# **FUNCTIONAL SERVICING REPORT**

## **TAMARACK (RICHMOND EAST) CORPORATION LANDS**

**DSEL PROJECT NO.: 18-1042**

**MARCH 20, 2025  
2<sup>ND</sup> SUBMISSION  
© DSEL**

WATERMAIN SERVICING PLAN	
SCALE: 1:5000	PROJECT No.: 1042
DATE: MARCH 2025	FIGURE: 04F

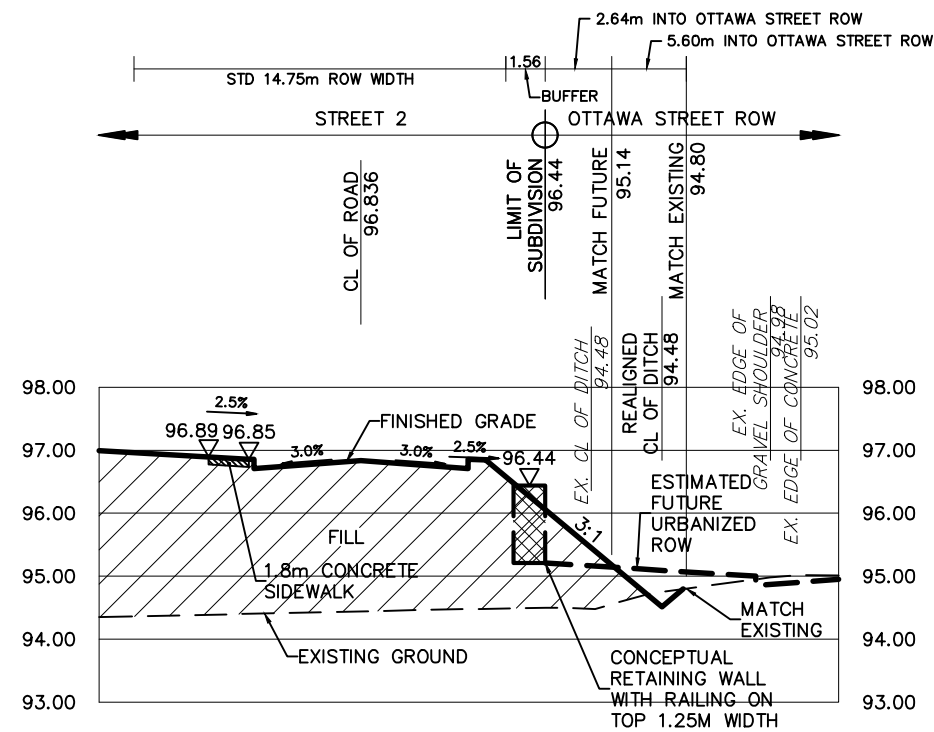
No.	Comment	Responsibility	
219	Figure 04F shows a design of a watermain passing through a rail corridor: draft approval will not be given until crystal clear, and irrefutable, written approval is given from the rail corridor holder to the City.	DSEL	Comment is no longer applicable.
220	Figure 04F shows a design of a watermain passing through lot, on McBean Street, for which ownership has not been proven.	DSEL	See <b>Comment 218</b> .
221	For figure 05F pressure-rated pipe and wrapped maintenance holes will be required.	DSEL	See <b>Comment 201</b> .
222	For figure 05F it is suggested that a wider difference be applied between the Barbie pink, of the forcemain, and the phlox purple, of the sanitary line being replaced.	DSEL	The colours in Figure 05F have been revised as requested.
223	An inlet, to the north sediment forebay, discussed in section 5.2, was not found in figure 06F.	DSEL	The inlet is included in the updated Figure 06F.

SCALE: 1:2000  
DATE: MARCH 2025  
PROJECT No.: 1042  
DRAWING: 01D

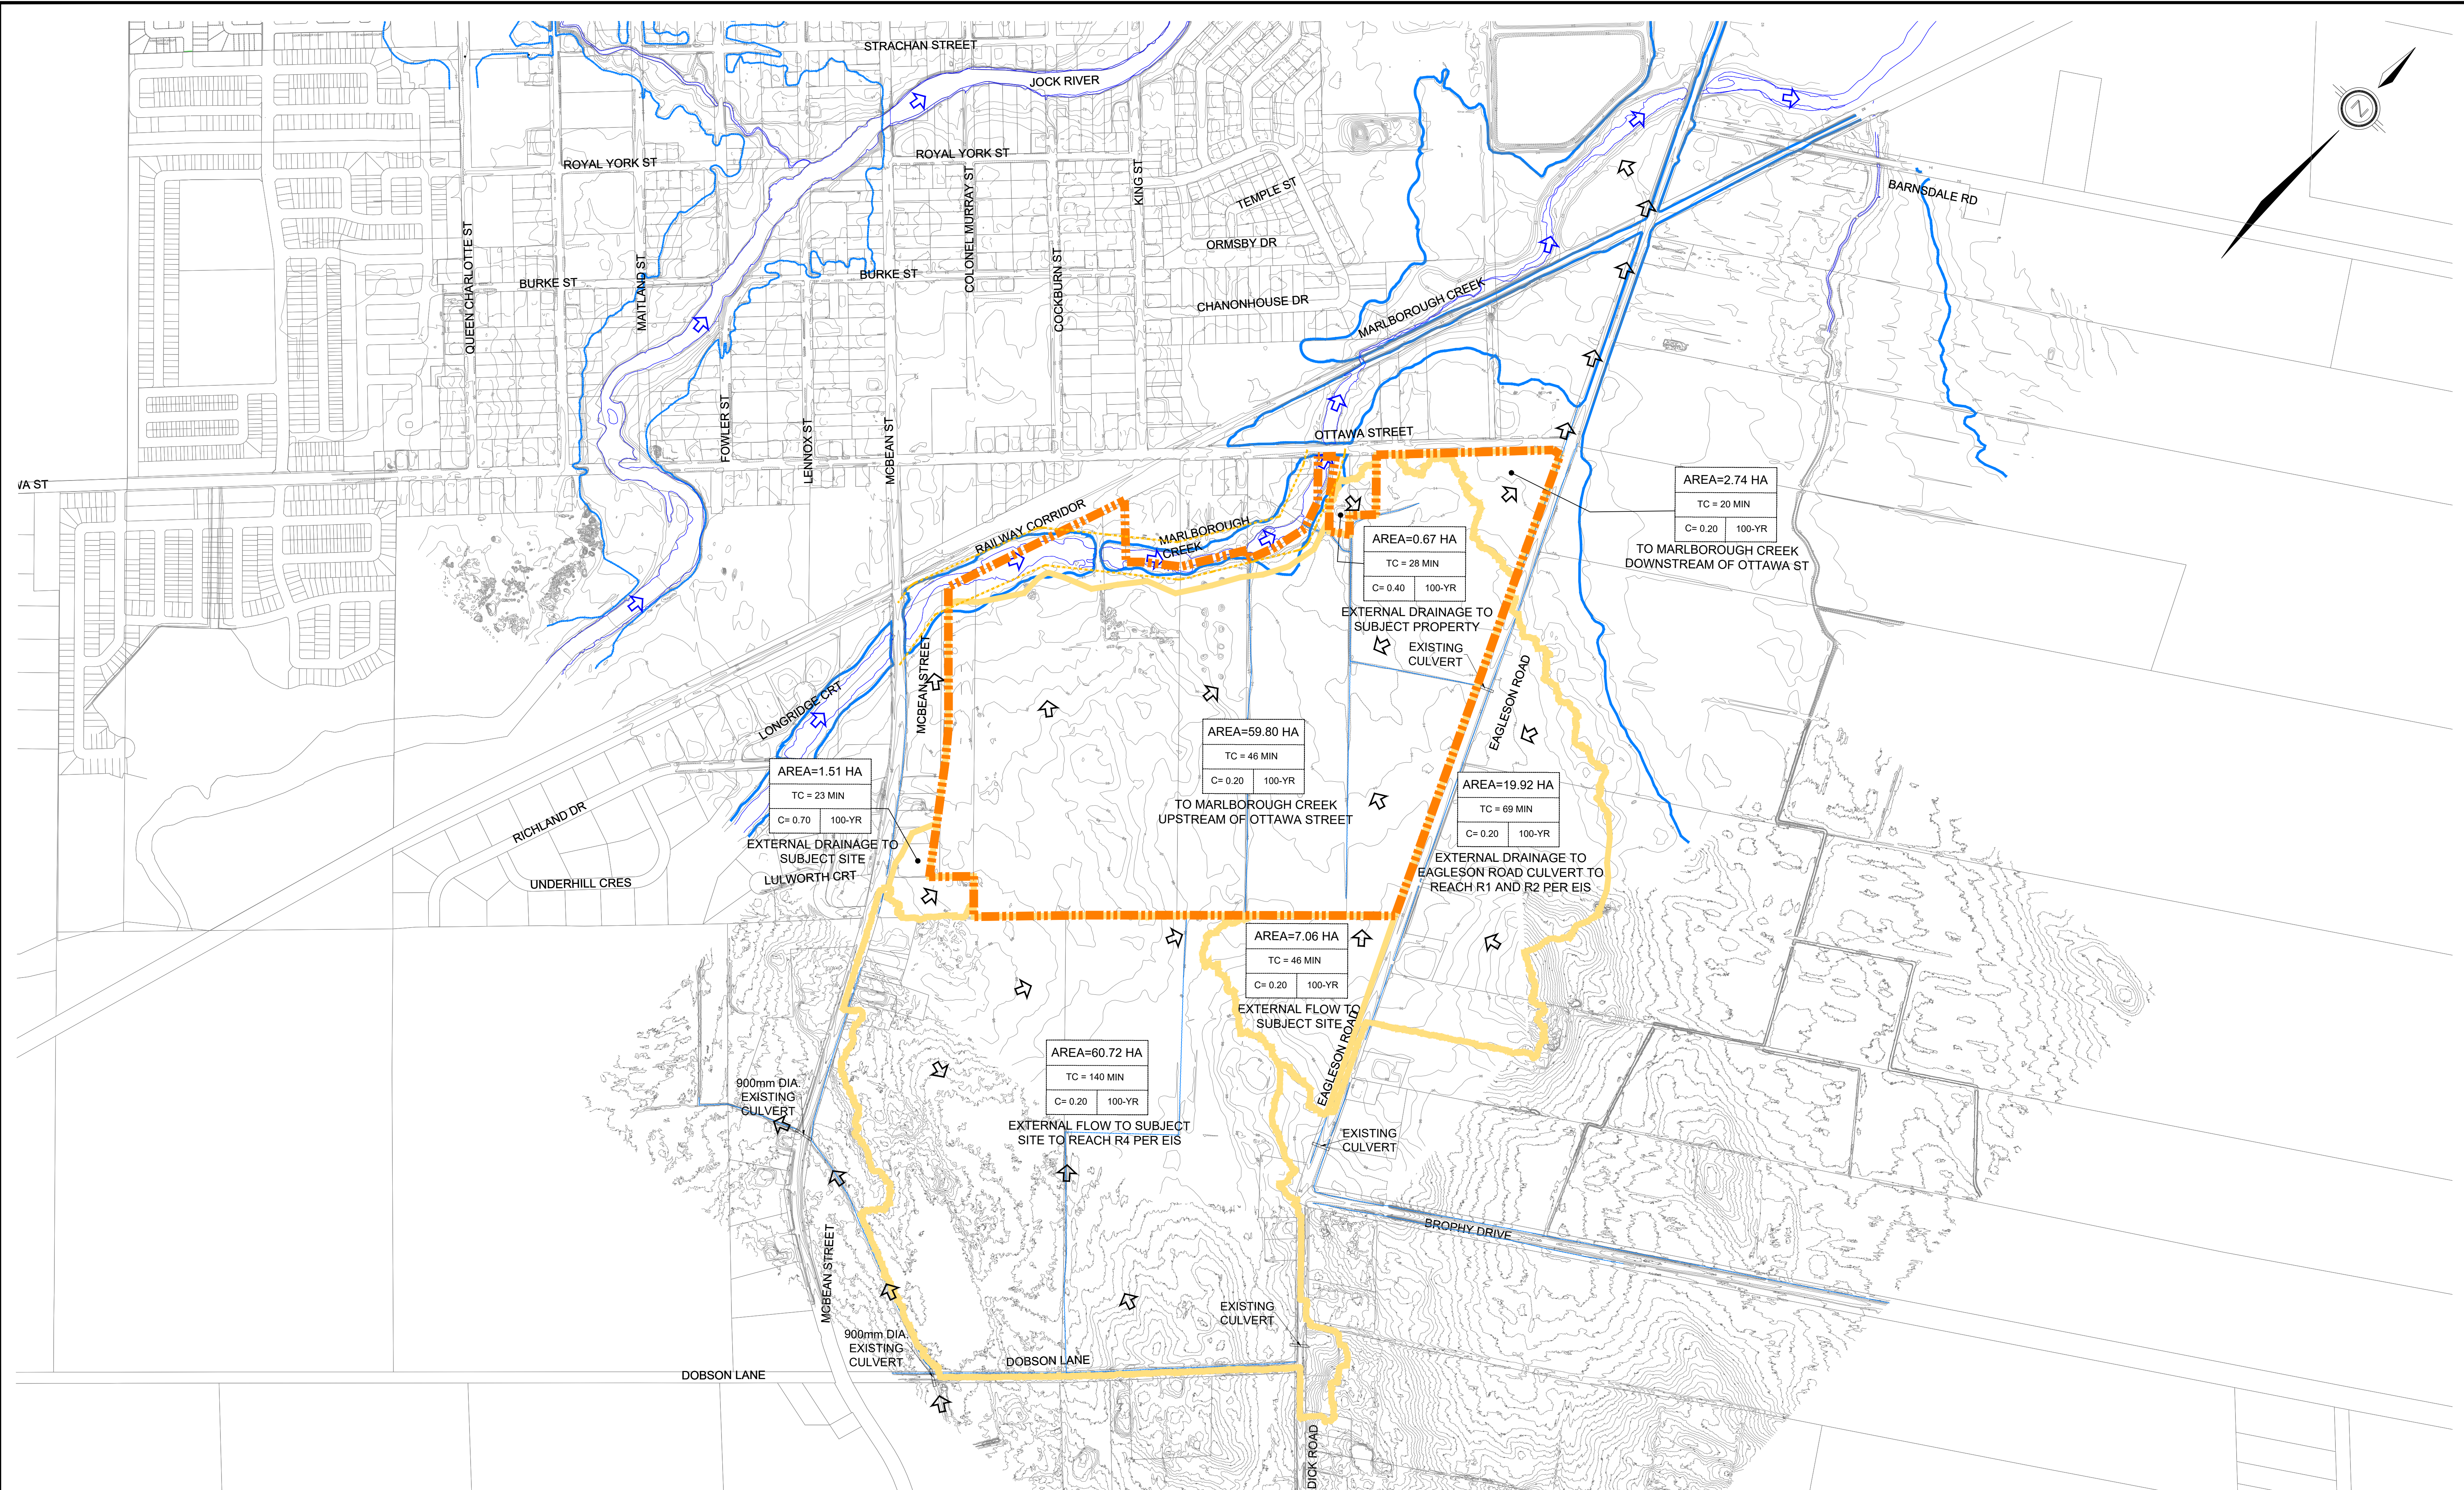
224	The grade raise shown in figure 06F suggests grade raise approaching the permissible limit.	DSEL	See <b>Comment 90</b> .
225	For drawing 01D, without sanitary design of the commercial area, upstream pipes will need be designed at 0.65% as per section 6.1.2.2 of the Guidelines.	DSEL	Comment no longer applicable as the latest development concept does not include the southern commercial area from the first submission.
226	For drawing 02d it is suggested that additional external areas should be included and the corner parcel, at the intersection of Ottawa Street and Eagleson Road, flowing out is smaller than shown.	DSEL	The drainage areas detailed in Drawing 02D have been defined based on the available topography of the area.
227	It is suggested that drainage easements over the commercial land will be required considering the comment shown on drawings 01D and 02D.	DSEL	Comment no longer applicable as the latest development concept does not include the southern commercial area from the first submission.

SCALE:	1:2000	PROJECT No.:	1042
DATE:	MARCH 2025	DRAWING:	04D

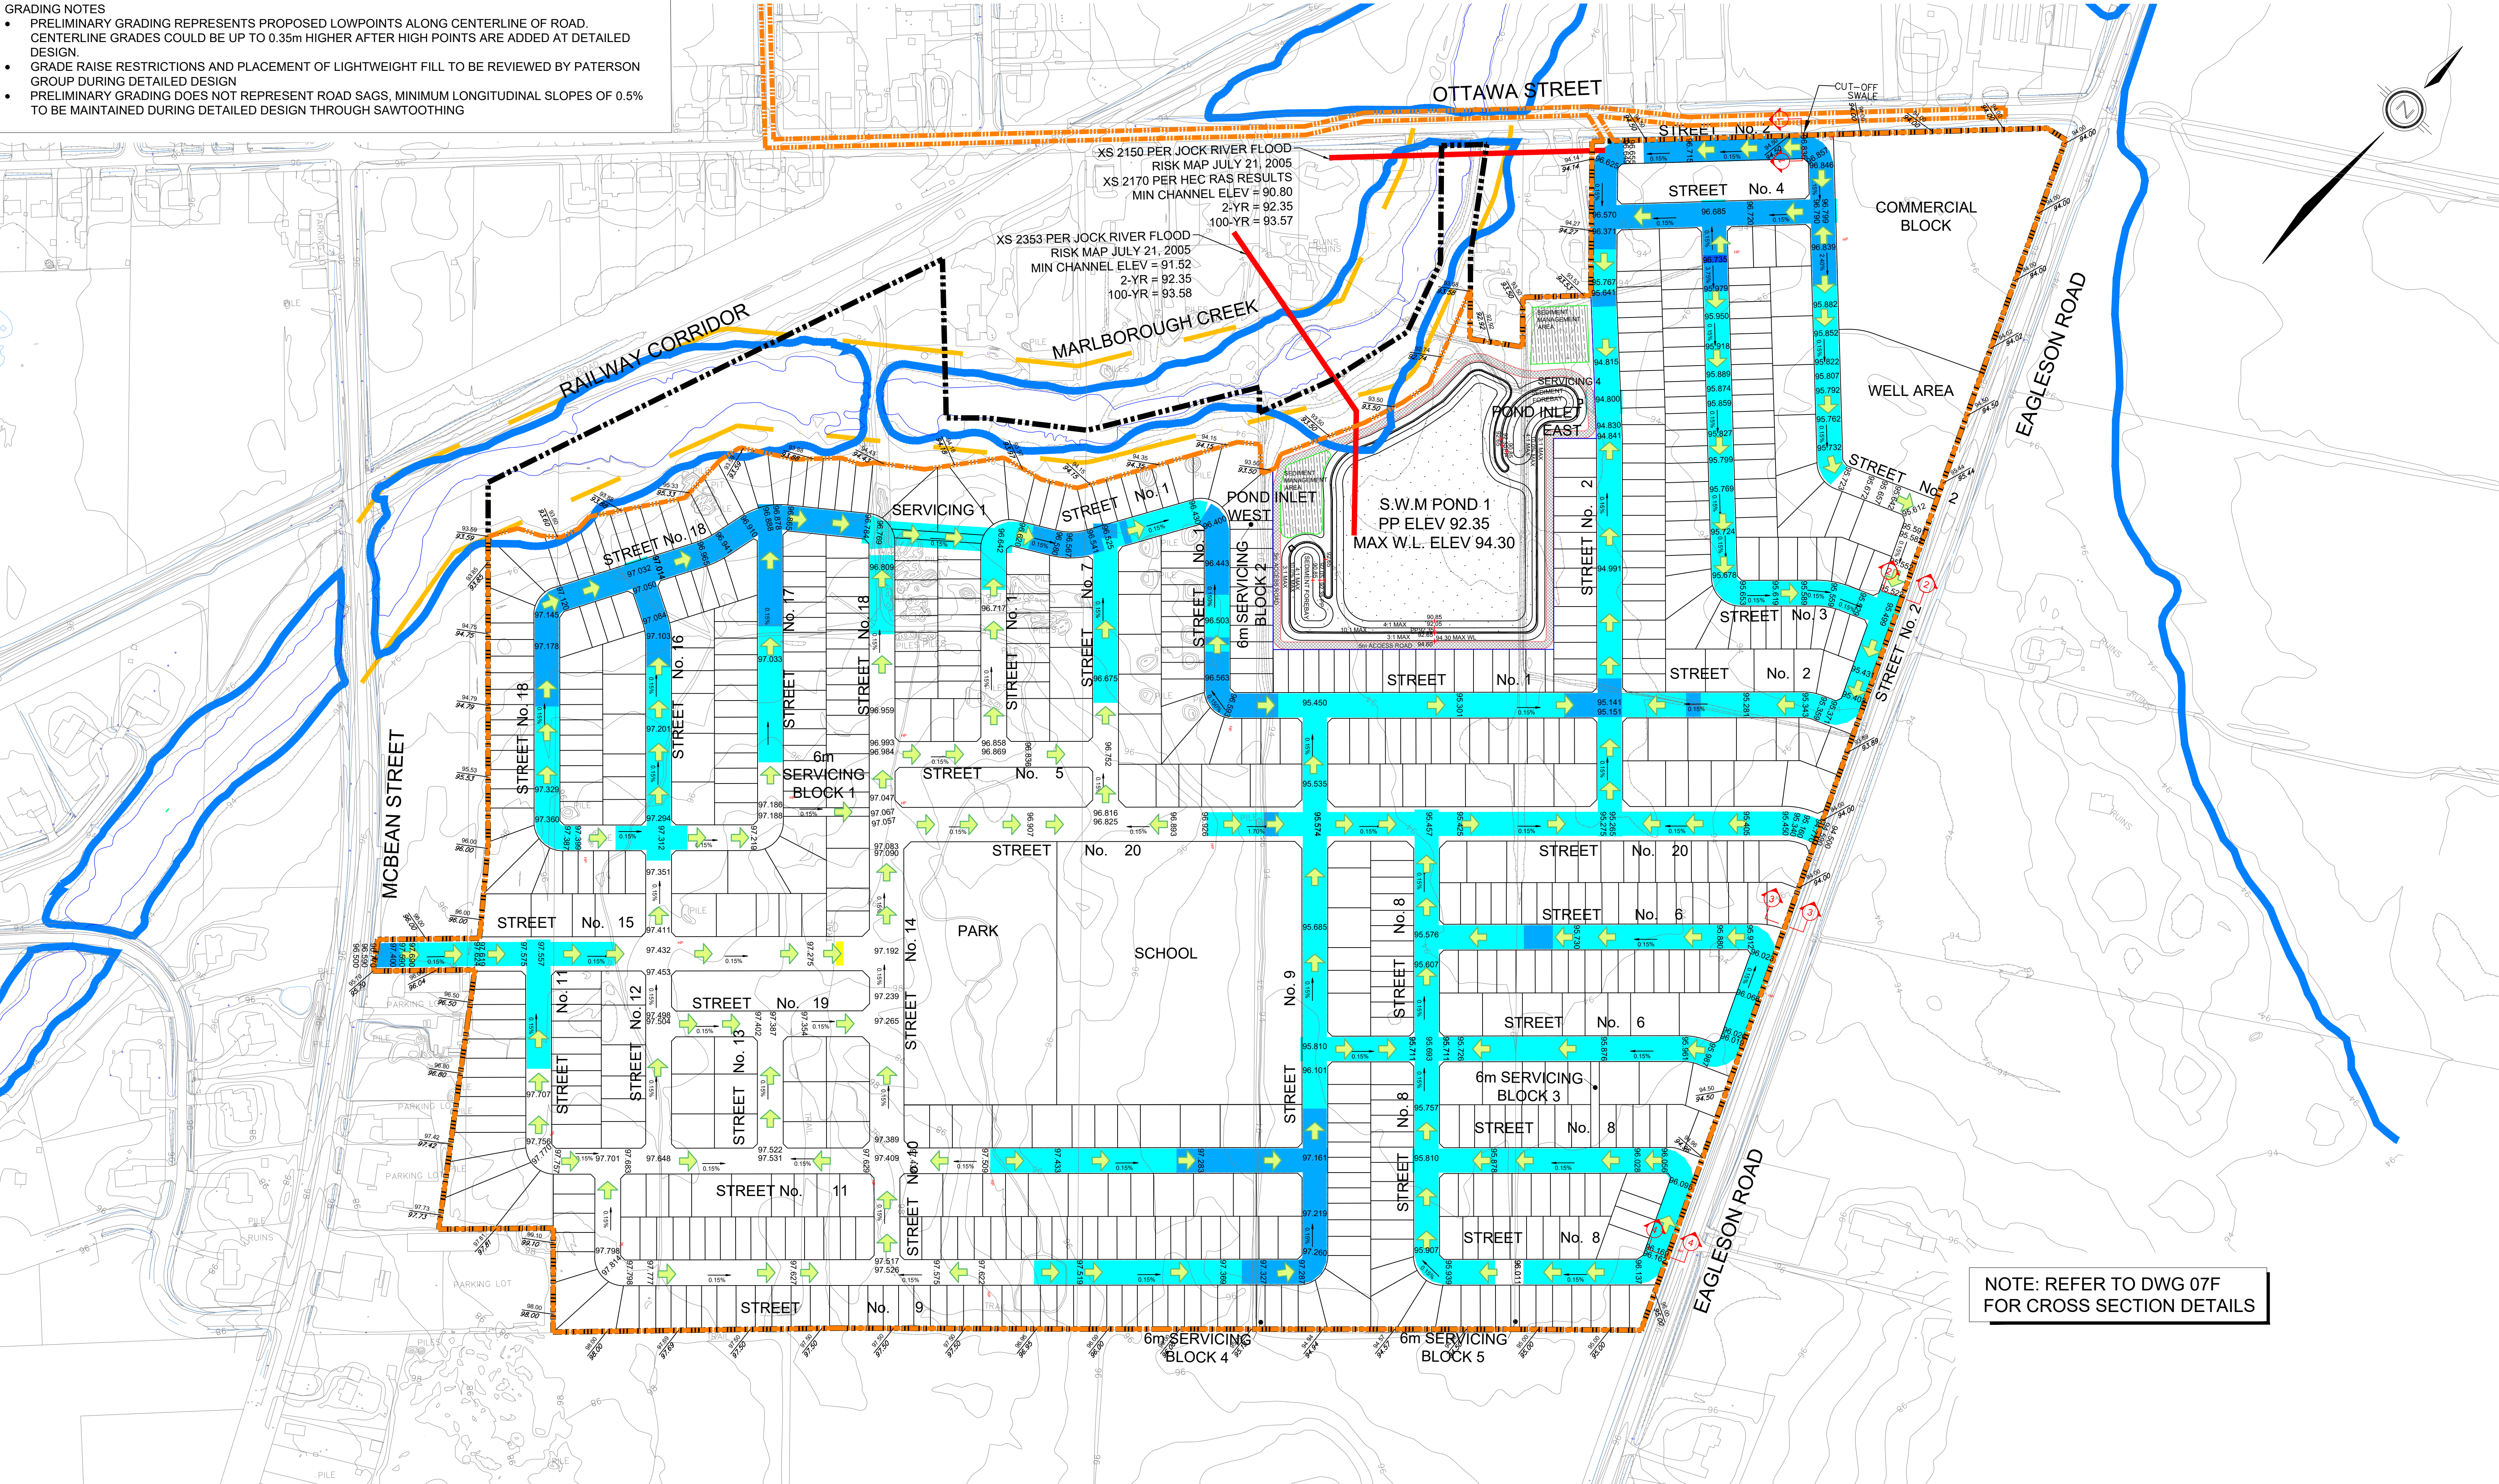
D.	<b>Grading Plan, 04D, prepared by DSEL, dated November 2020</b>	Responsibility	Action
90	Preliminary comments: <ul style="list-style-type: none"> <li>• It appears the plan shows a grade raise beyond that permitted.</li> </ul>	DSEL	Drawing 04D has been updated as part of this submission. The preliminary road grades shown respect the grade raise restrictions for the site.  As part of detailed design, Paterson will conduct a review of the detailed grading for the site to confirm.
